"That Council authorize the issuance of Development Permit Application No. 00054 for 1800 Quadra Street, in accordance with:

Re: Development Variance Permit Application – 1800 Quadra Street

1 SOUTH ELEVATION (PROPOSED)
 A-3.1 SCALE: 1/8" = 1'-0"

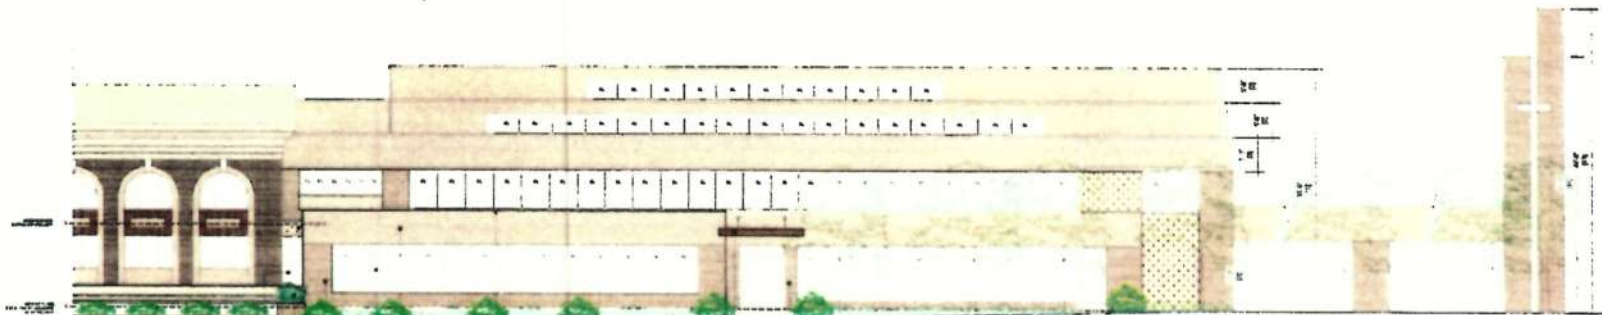
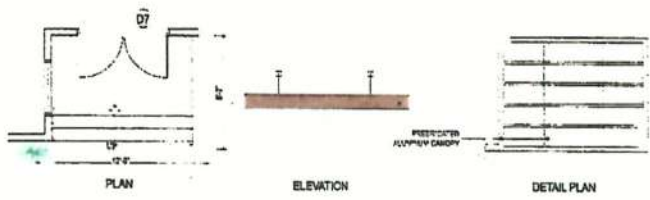
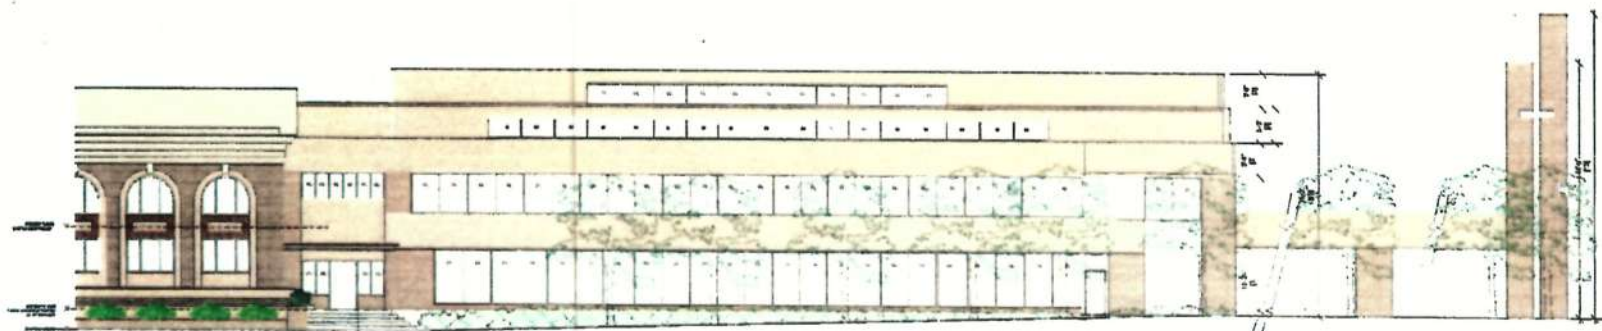
The proposed building façade would provide visual interest along the street and includes materials and details that would fit with the existing building to the east. The proposal does not,

however, respond to the context of the existing older portion of the building to the west in terms of building elements such as façade rhythm and horizontal cornice lines.

The applicant is proposing to provide a 0.91m break between the existing western portion of the building and the proposed addition. This would help differentiate between the two portions of building that were built at different times and have different styles. The existing older portion would not, however, retain its prominence over the newer addition because the proposed addition would be located closer to the street.

The applicant is proposing to reduce the minimum setback from a building to the south lot line from 6m to 0.405m. This variance will impact the public street and sidewalk by permitting the building to be located closer to North Park Street than is currently allowed. The sidewalk at this location is located close to the lot line. To help soften the impact on the street the applicant is proposing to have a landscape planting strip located between the addition and the lot line. The proposed addition would also provide a connection to the public street with windows and a covered entry.

The applicant is proposing a variance to increase the maximum aggregated horizontal distance of a structure from 30m to 38.20m. To help break-up this length of façade, the applicant is proposing to provide a 0.909m wide break between the existing building located to the west and the proposed addition. This would help differentiate between the two portions of building.

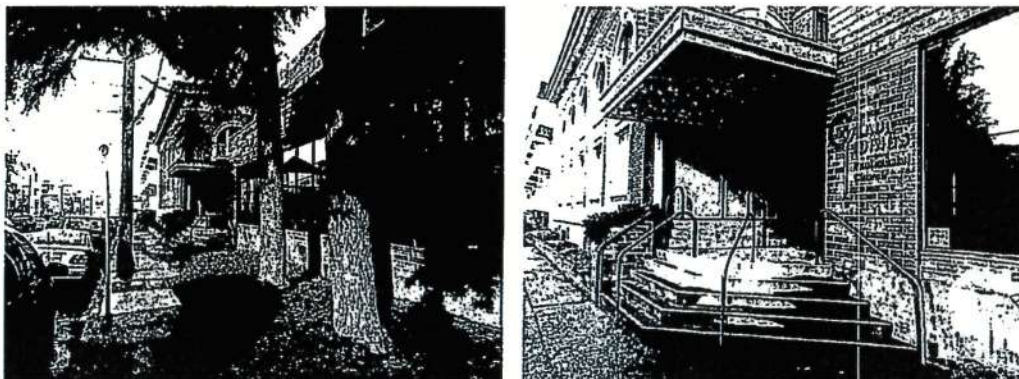
Existing church building built in early 1900s is 0.9 metres from property line, the planter extends further towards sidewalk, with 1979 church building beyond.

Location of proposed one storey lobby addition. Reduced setback would not feel out of character along the north side of North Park. Existing stairs are steep and not accessible. Area to be enclosed and ramp access created from new lobby.
